**DECLARATION OF BRADLEY J.  
HERREMA IN SUPPORT OF MOTION  
FOR COURT APPROVAL OF 2023  
RECHARGE MASTER PLAN UPDATE**

DATE: September 28, 2023  
TO: Board Members  
SUBJECT: 2023 Recharge Master Plan Update and Resolution No. 2023-06 (Business Item II.A.)  
SUMMARY:

# 2023 Recharge Master Plan

Figure 1-3. Streambed Infiltration and Managed Recharge of Stormwater in the Chino Basin, 1978-2022

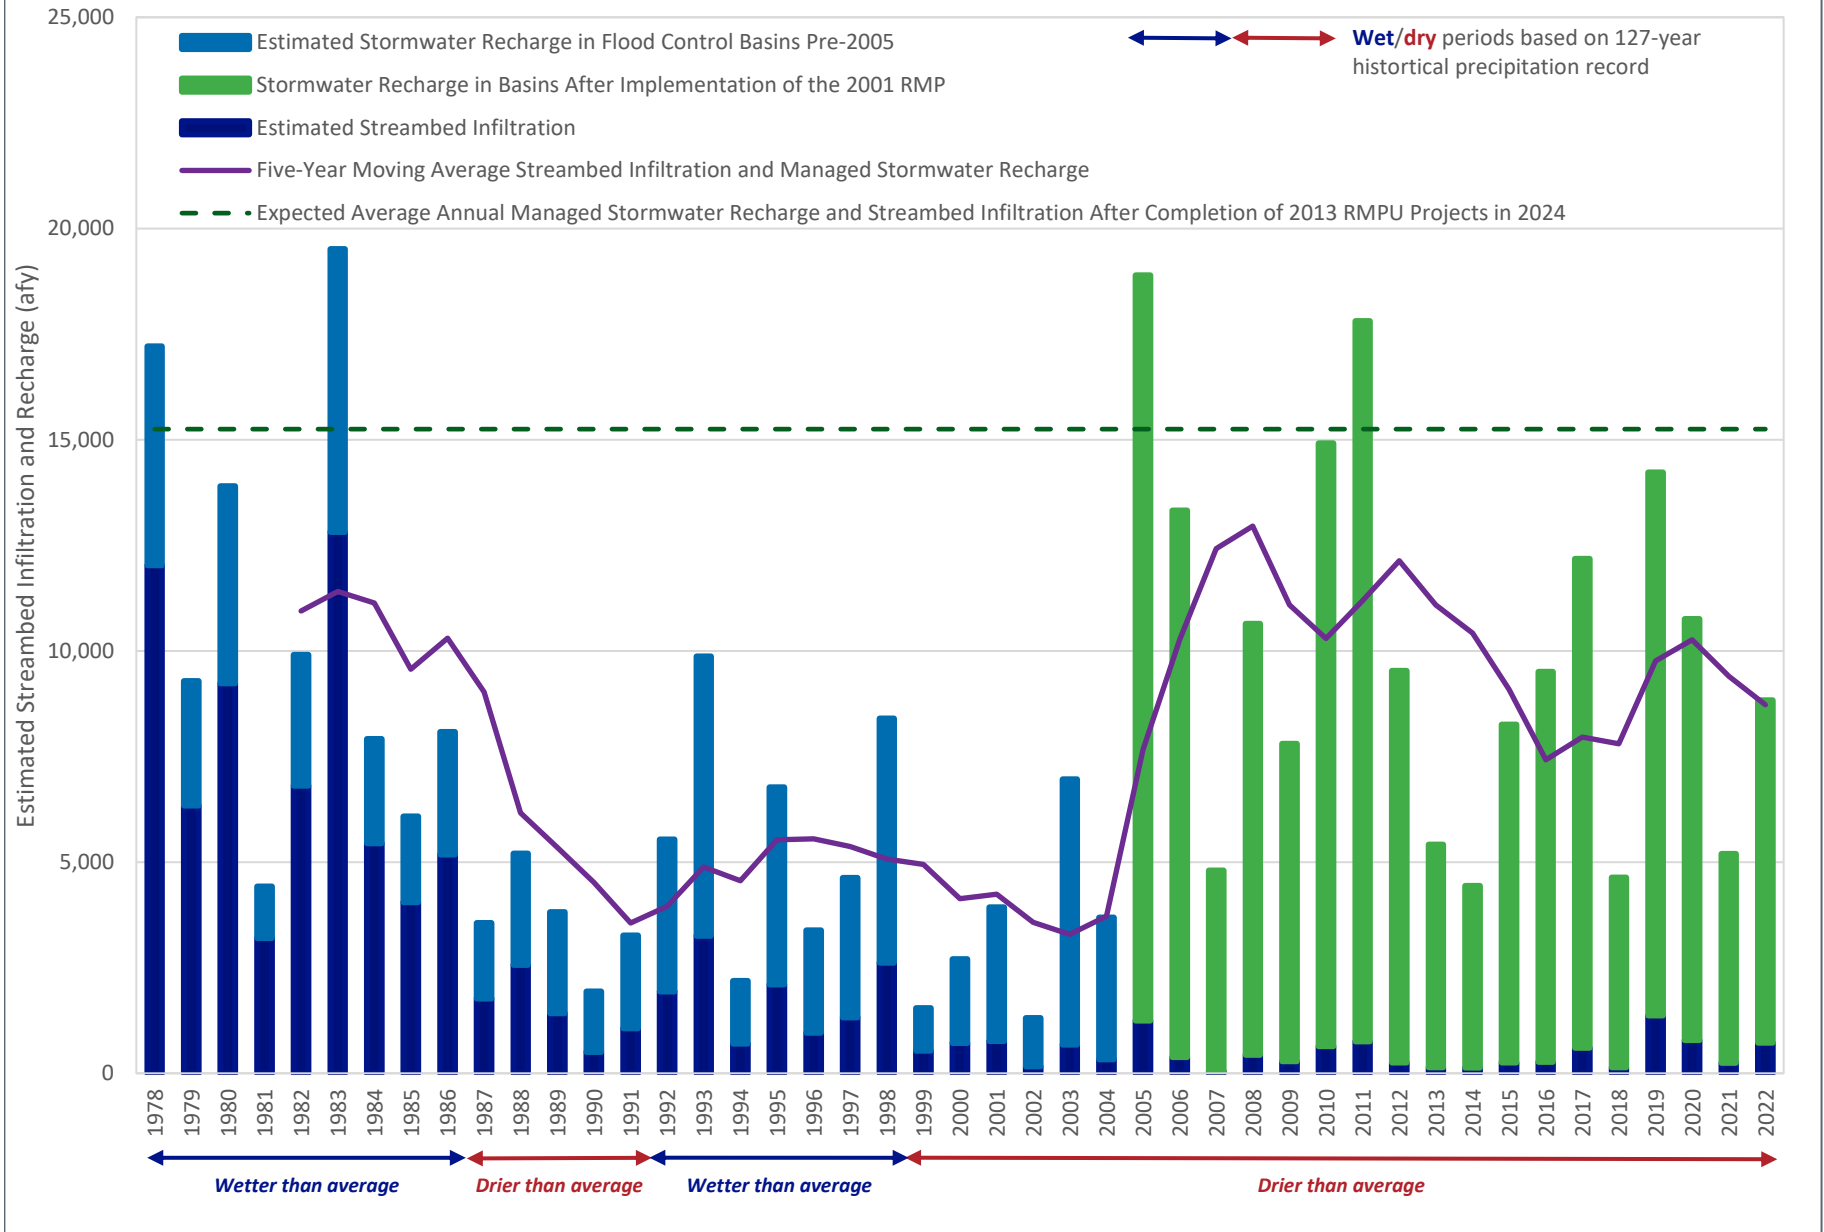
### **Comment 1 – Page 1-6: “Figure 1-3. Estimated Streambed Infiltration for the Santa Ana River Tributaries in the Chino Basin and New Recharge Resulting from Recharge Master Plan Implementation, 1978-2018”**

See above comment re Figure 1-3. We recommend this be rewritten to recognize the activities of the Chino Basin Water Conservation District in recharging stormwater and dry-weather runoff prior to 2004 and up to today.

Figure 1-3 has been updated to show all historical managed stormwater recharge.

Figure 3-3. Historical Groundwater Discharge from CCWF (FY 2004/05 to FY 2017/18)

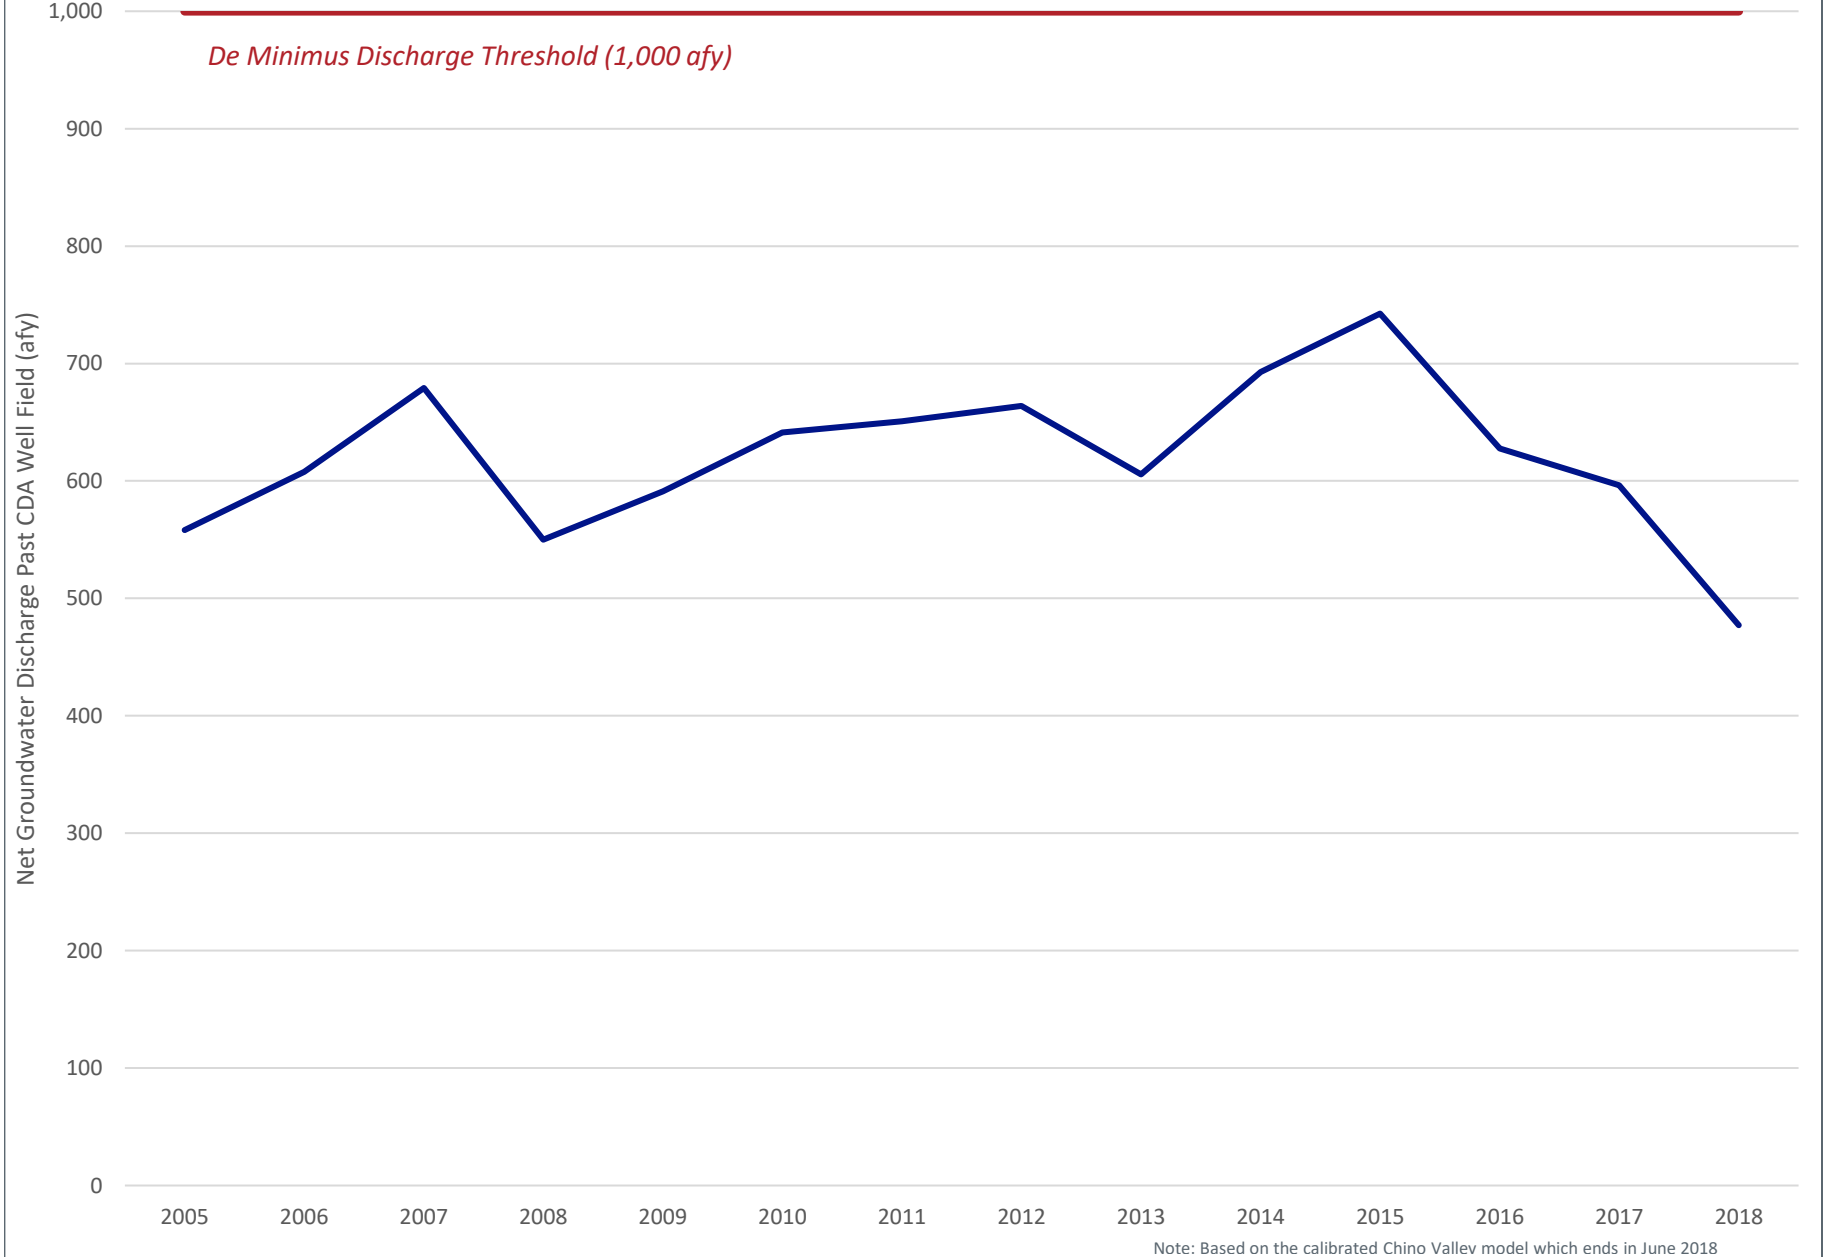
Figure 3-3 shows through 2018 and narrative states through 2023. Include note regarding model timeline.

The narrative has been updated to clarify that Figure 3-3 shows data through 2018 and that information regarding hydraulic control from 2018 to 2023 is based on the Chino Basin OBMP Maximum Benefit Annual Reports.

Figure 4-1. Comparison of Aggregate Water Demands in the Chino Basin for Various Planning Investigations

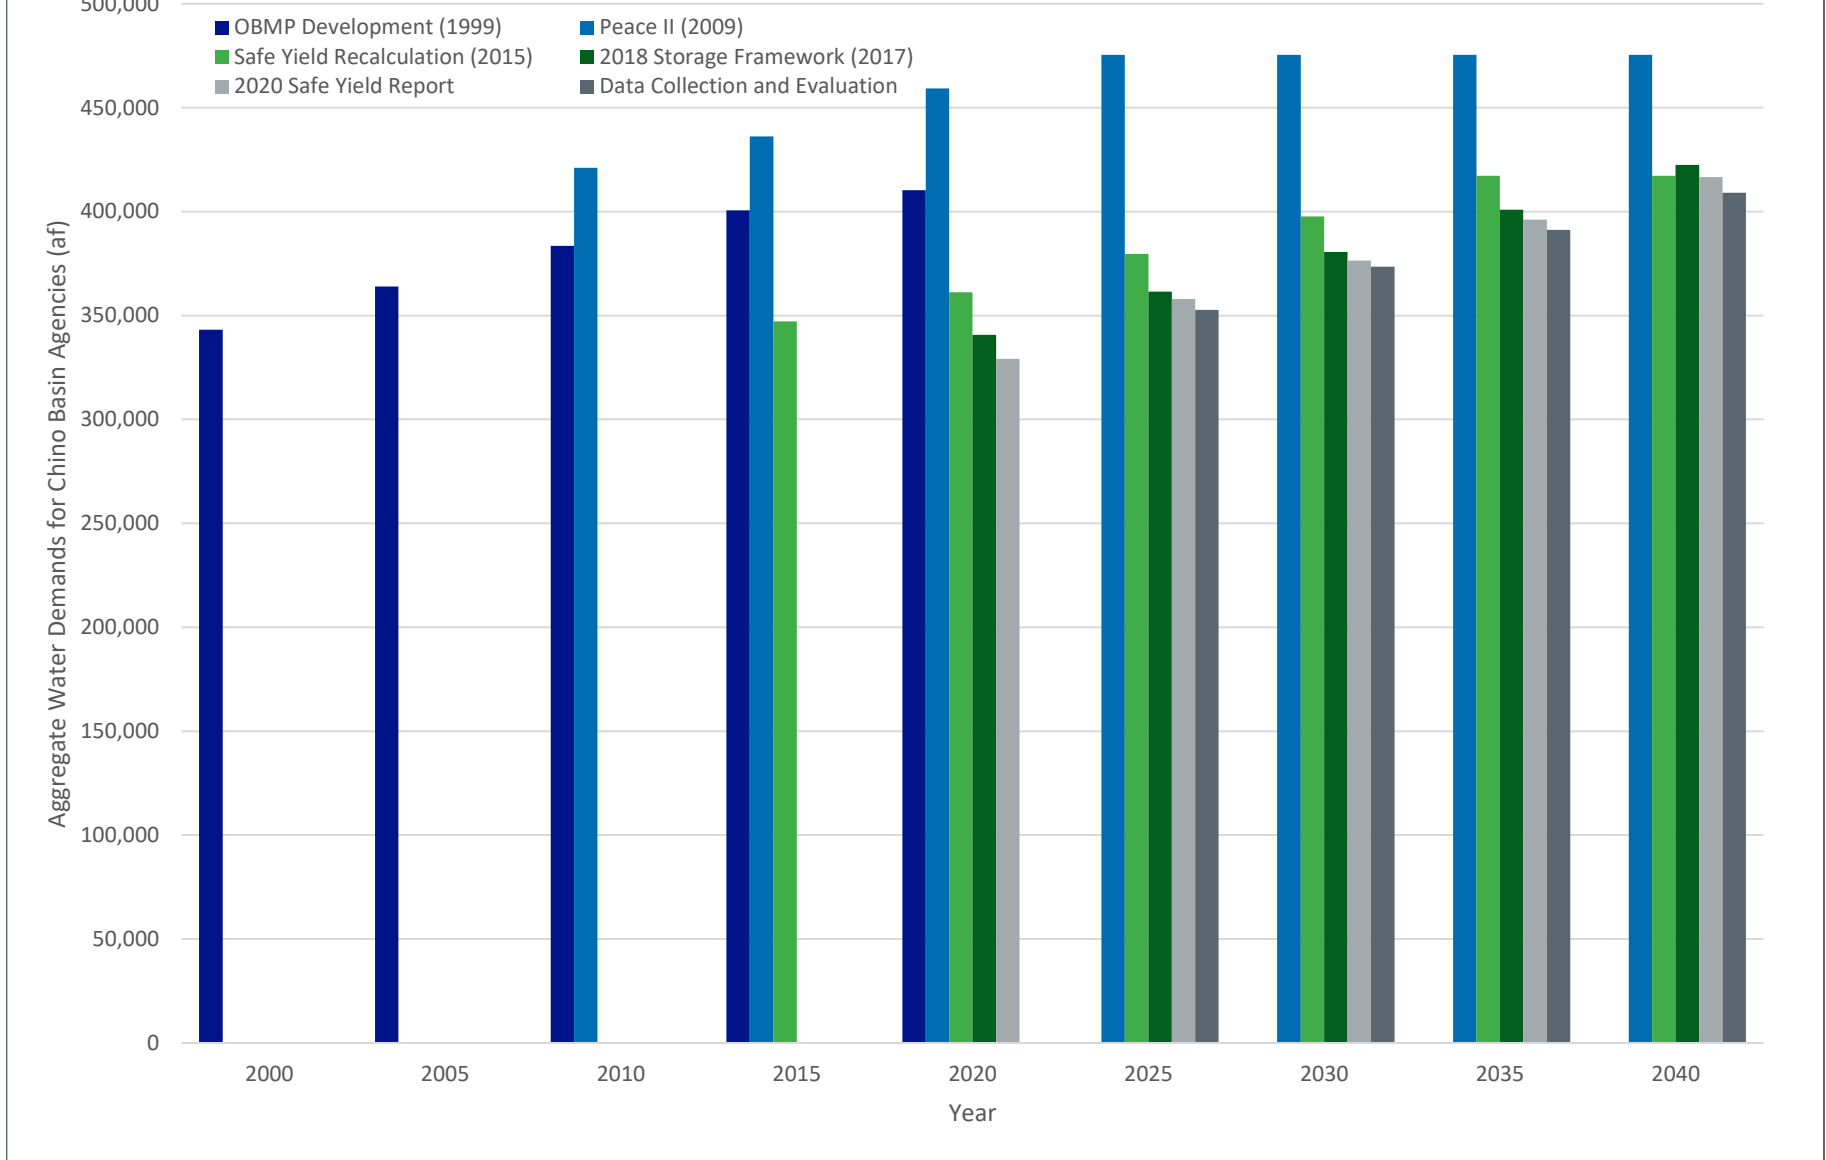
#### Comment 6 – Figure 4-1

**Comment 11 – Figure 4-1.**

Figure 4-1 was updated.

Figure 4-1 was updated.

Figure 4-3. Projected Annual Supplemental Water Replenishment and Recharge Requirements, 2023-2045

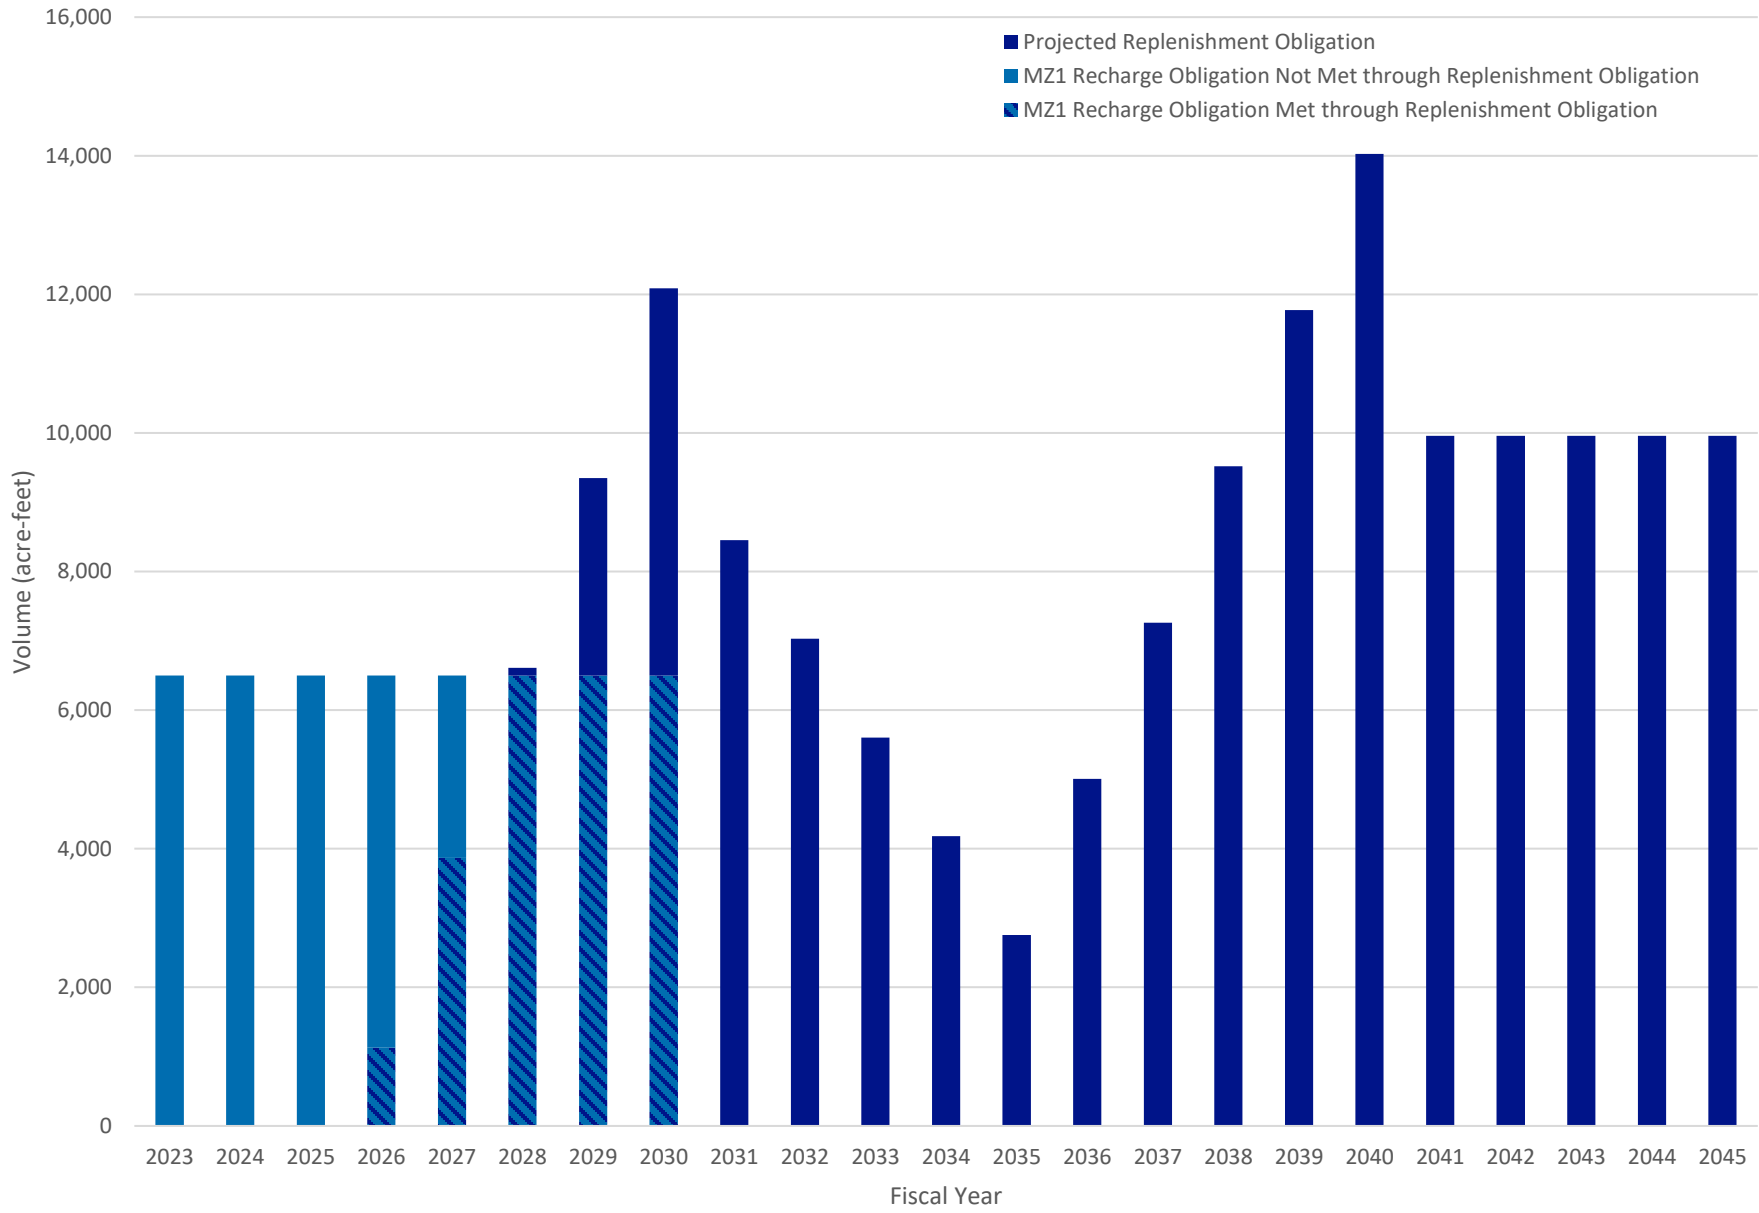
#### Comment 7 – Figure 4-3

**Comment 13 – Page 4-5: “Figure 4-3 also shows the 6,500 afy supplemental water recharge obligation for MZ1 through 2030.”.**

Figure 4-3 was updated to show that replenishment obligation is used to meet the MZ1 recharge requirement.
